# Access Compliance Report

## Public Rights-of-Way

Intersection ID: 6144	Main Street: BACK_CREEK_CHURCH_RD	Cross Street: COREOPSIS_RD	Location: SE
ADA ID: 05BF02E798E9	Ramp Type: Perp	Initial Pass/Fail: Fail	Overall Compliance: No
Codes/Mitigation Info/Possible Solution		Field Measurements/Component Compliance	
Severity Score: 13.75

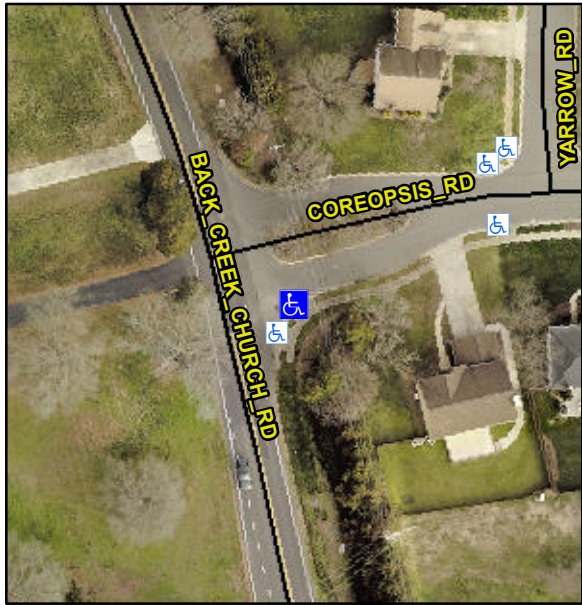
Not Found, R304.2.2, R304.5.3

Compliance	Description	Data	Compliance	Description	Data
N/A	Ramp Length (in)	95.0	No	Ramp Slope (%)	9.6
Yes	Ramp Width (in)	60.0	No	Ramp XSlope (%)	3.7
N/A	Flare Type LT	N/A	N/A	Flare Type RT	N/A
N/A	Flare Slope LT (%)	N/A	N/A	Flare Slope RT (%)	N/A
N/A	Flare Traversable LT?	N/A	N/A	Flare Traversable RT?	N/A
N/A	Landing Length (in)	N/A	N/A	DWS Provided?	N/A
N/A	Landing Width (in)	N/A	N/A	DWS Contrast?	N/A
N/A	Landing Slope (%)	N/A	N/A	DWS Length (in)	N/A
N/A	Landing X Slope (%)	N/A	N/A	DWS Full Width?	N/A
N/A	Landing Curb? (Y/N)	N/A	N/A	DWS Offset (in)	N/A
N/A	Shared Landing?	N/A			
N/A	Gutter Ponding?	N/A	N/A	Gutter Slope (%)	N/A
N/A	Gutter Lip Ht (in)	1.0	N/A	Gutter X Slope (%)	N/A
N/A	Painted X Walk1?	No	N/A	Painted X Walk2?	N/A
	X Walk 1 Direction	To NW		X Walk 2 Direction	N/A
N/A	X Walk 1 Width (in)	N/A	N/A	X Walk 2 Width (in)	N/A
	X Walk 1 Slope (%)	0.3		X Walk 2 Slope (%)	N/A
	X Walk 1 X Slope (%)	2.5		X Walk 2 X Slope (%)	N/A

Remove & Replace Entire Ramp.
